# Village of East Hampton Wastewater Management Peer Review & Recommended Engineering Plan Report

December 22, 2021  
Updated Through June 26, 2022

Environmental Engineers/Consultants  
**LOMBARDO ASSOCIATES, INC.**

**Figure 6-3 Proposed Water Resource Recovery Facility Layout**

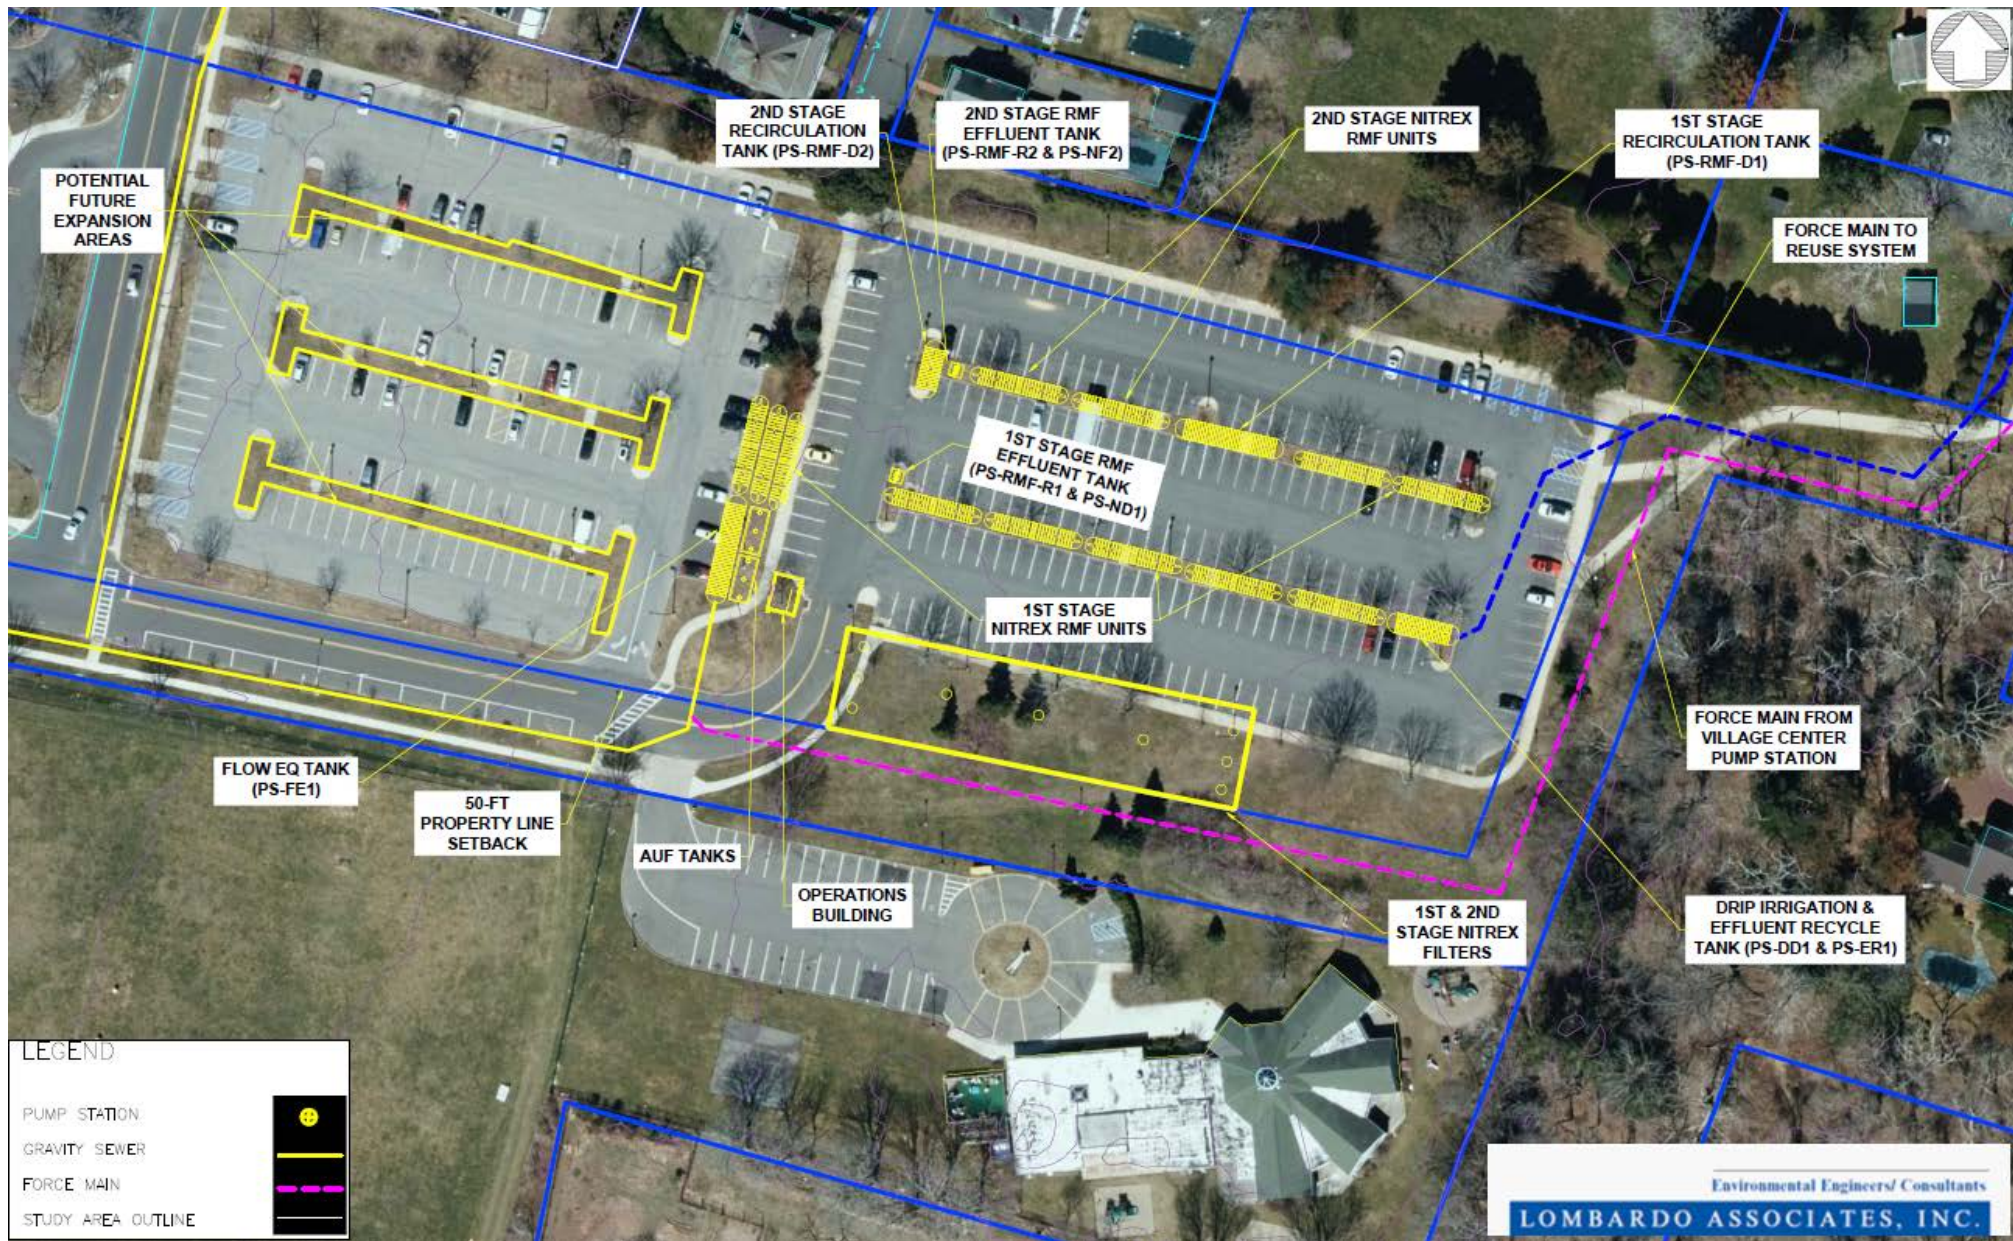
Tables 4-2 & 4-3 present current code flows at 66,000 gpd. The 10,000 gpd contingency is 16% of existing code flow. The Village will be seeking project funding from the Town's Community Preservation Fund (CPF). CPF funds cannot be used to fund growth. Should the Village need capacity for additional expansion, the Town parking lot adjacent to the proposed site is available and would be used, see Figure 6-3 of the revised Engineering Plan.

**Figure 6-5 Proposed Sewer in Wetland Areas-Limits of Disturbance & Erosion Controls**

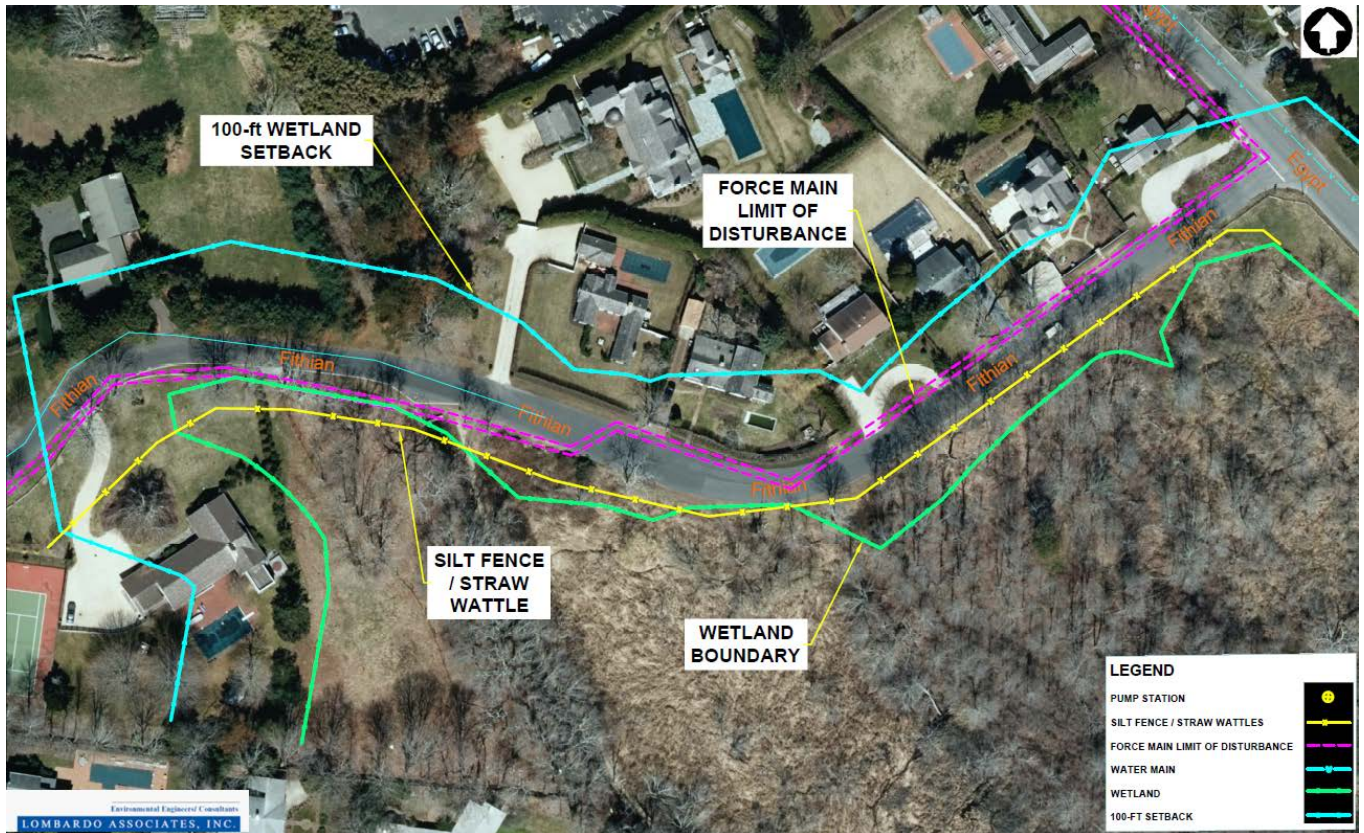
1. The area south of Fithian Lane contains the northern extend of NYS regulated freshwater wetland EH-3, which may be impacted by the installation of the force main. You must revise the pages depicting work in this area to show the freshwater wetland boundary. If any work is proposed within 100' of the freshwater wetland boundary, then the plans must show a limits of clearing and ground disturbance line as well as any necessary erosion controls.

1. You must provide more detailed information for the proposed STEG and STEP systems in Section 6.2, including general sizes for each residential and commercial area. Detailed drawings, calculations and narratives are required for each pump station.
2. The pH limits in Section 6.3 are noted as ranging from 5.5 to 8.5. This must be corrected to the acceptable range of 6.5 to 8.5.
3. Figure 6-5 on page 41 appears to be missing the proposed sewer route.

**The Report has been accordingly revised.**

Figure 6-6 Work in Wetland Jurisdictional Areas - Erosion Controls

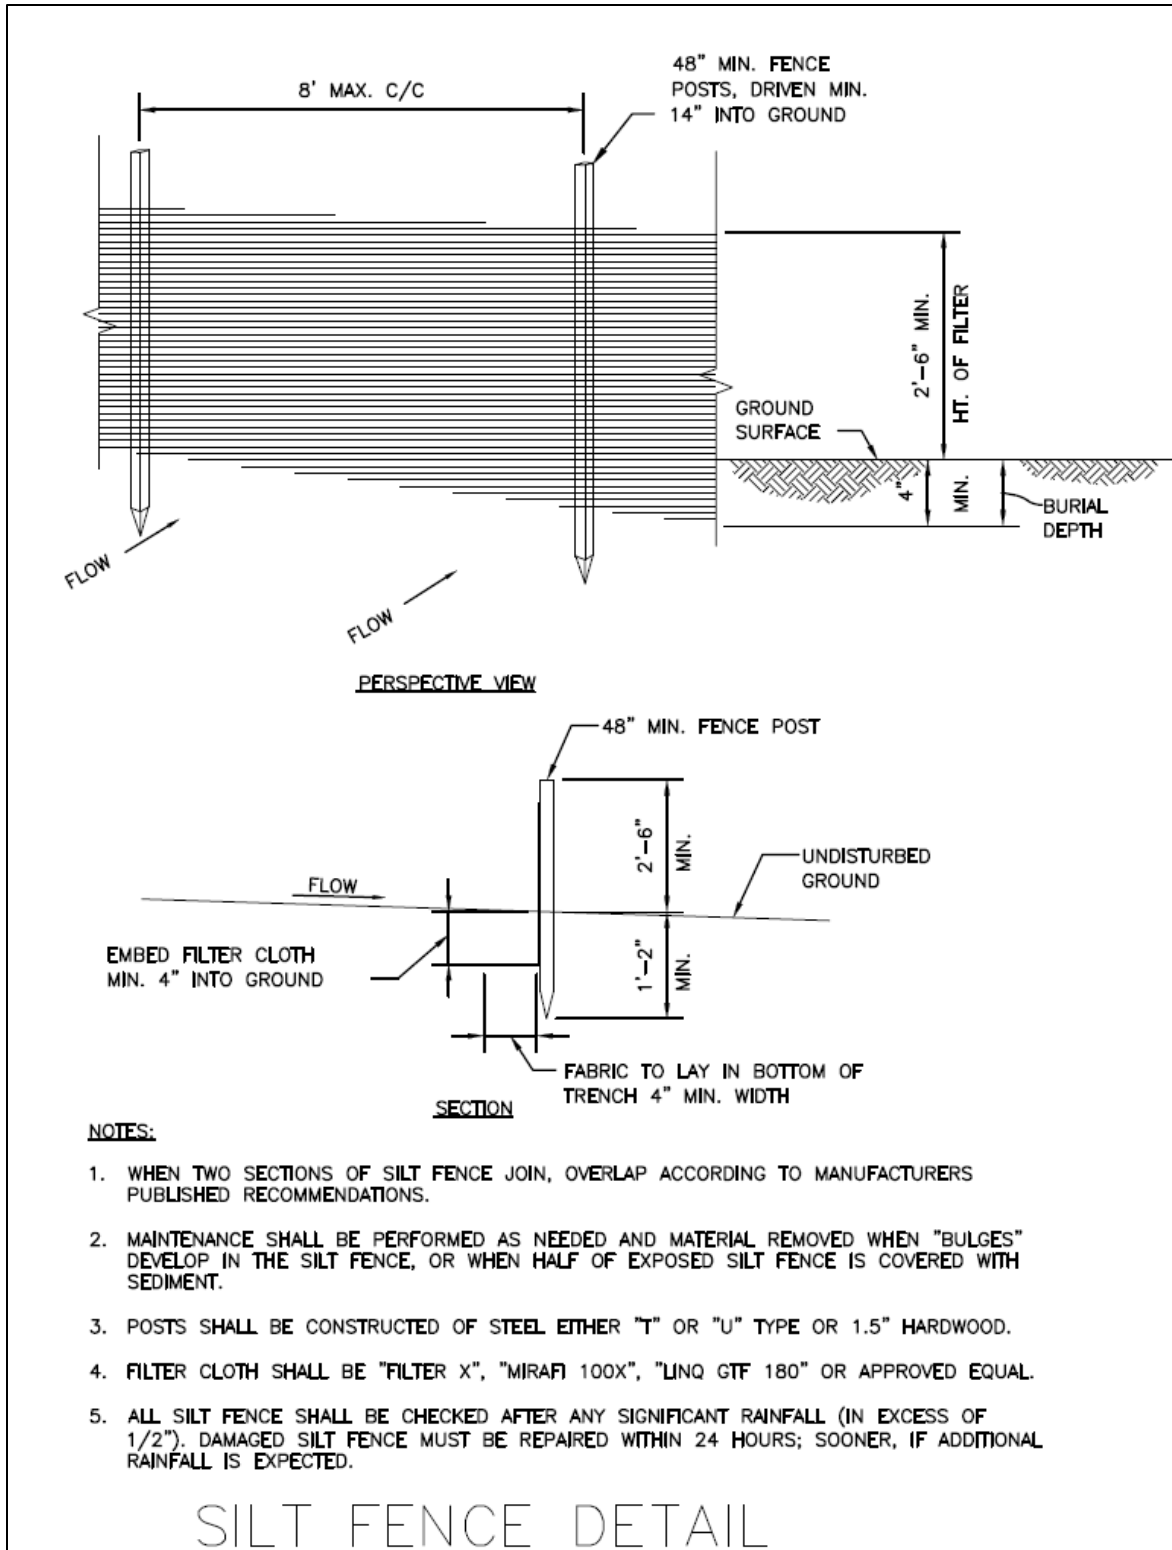
7. Please provide calculations for the Nitrex denitrification filter.
8. Figure 6-6 notes straw wattle proposed for erosion and sediment control. Straw wattle is not an approved method per the New York State Standards and Specifications for Erosion and Sediment control, and must be removed from the drawing.
